Interactive comment on “Predicting effects of plantation expansion on streamflow regime for catchments in Australia” by L. Zhang et al.

Comments from reviewer #1:

Fig. 1. Normalising the FDC to achieve common parameter space.

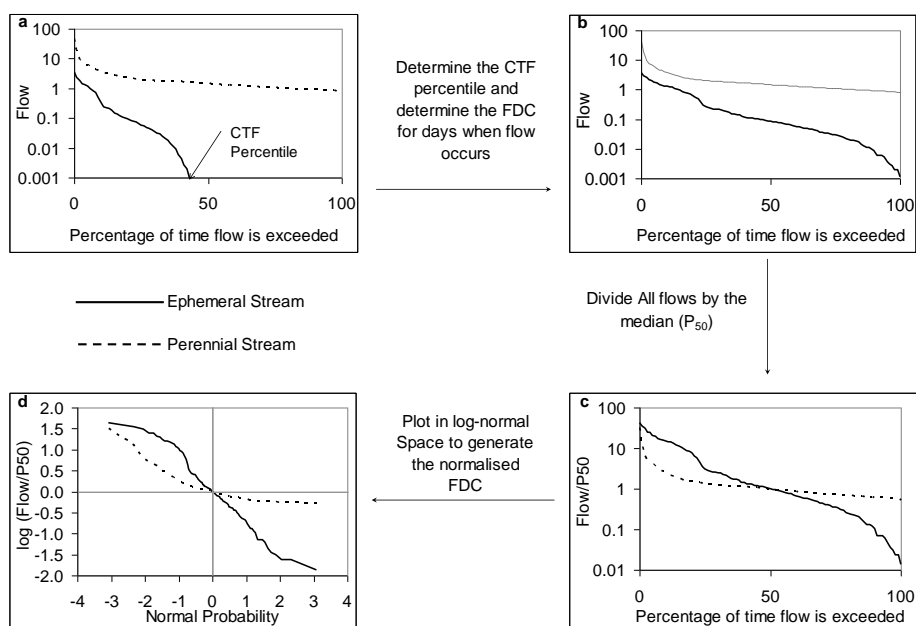
Q1: Chapter 2. Model description Obviously, the FCFC model consists of three parts such as the parameterization of the FDC-curve, calculation of mean annual water yield, and a simple bucket model to calculate the percentage of time the flow occurs in a given catchment. In the recent paper, only the parameterization of FDC-curve is described. I would like to recommend to add a short and concise description of the total FCFC-model. From my point of view, outstanding readers of the paper should be able to understand the basics and assumptions of the model applied in this study without reading some furthers papers or the model manual. Without such a description, the reader has no sufficient information e.g. how an increase of forest cover is incorporated in the FCFC-model. The quality of fit is described by the Nash-Sutcliffe Index (NSI). What are the ranges for the FCFC-model for a good or bad fit? In addition, as far as I know, NSI was mainly designed for discharge rates and is mainly sensitive to a good correspondence between observed and calculated peak flows. Is NSI really appropriate for a description of the fit of predicted and observed FDC-curves?

Q8: Technical remarks Please add the sources of Fig. 1 and 2 (FCFC-Manual?). Fig. 3: legend and descriptions are very small.

Response to Q1: Thanks for the comment. We have made major changes in the model description and it should now be clear how FCFC predicts FDC associated with a new forest cover in a catchment. The reviewer is right that the Nash and Sutcliffe efficiency is more sensitive to peak flows. In this study, we used logarithm of flows to give more weight to low flow values and a number of studies showed that the use of the Nash and Sutcliffe efficiency is appropriate for describing FDCs (Best et al., 2003; Brown et al., 2006; Brown, 2008). The detailed descriptions for FCFC model are as follows.

The FDC within FCFC is represented by a five parameter model in equation (1) as described by Best et al. (2003). The FCFC model normalizes the FDC so that $Q_{50} = 1$ and $CTF = 0$ and this facilitates the estimation of the remaining three parameters. Fig. 1 shows the method used to normalise the FDC of perennial and ephemeral streams. Firstly, the cease-to-flow (CTF) percentile is established (Fig. 1a). The CTF percentile is defined as the ratio of the number of non-zero flow days to the total number of days. A non-zero flow day is defined as any day on which flow is greater than or equal to a specified threshold value (adopted here as 0.001 mm/day). A FDC is then constructed using only the days on which flow is greater than the threshold value as streamflow measurements below this value are considered unreliable (Fig. 1b). The FDC is then normalised by dividing all flow values by the conditional median (Fig. 1c). Finally, the FDC is plotted in log-normal space (Fig. 1d) to produce a normalised FDC (NFDC). This normalisation procedure results in all of the NFDCs intersecting the origin.

Response to Q8: Changes have been made as suggested. Section 2.2 has detailed described the FCFC model including the sources of Fig. 1 and Fig. 2. It should be noted that new Fig.2 is used in the revised manuscript. The detailed FCFC model description can be referred from the response to the first comment above. We have also enlarged Fig. 3 to make it clear.
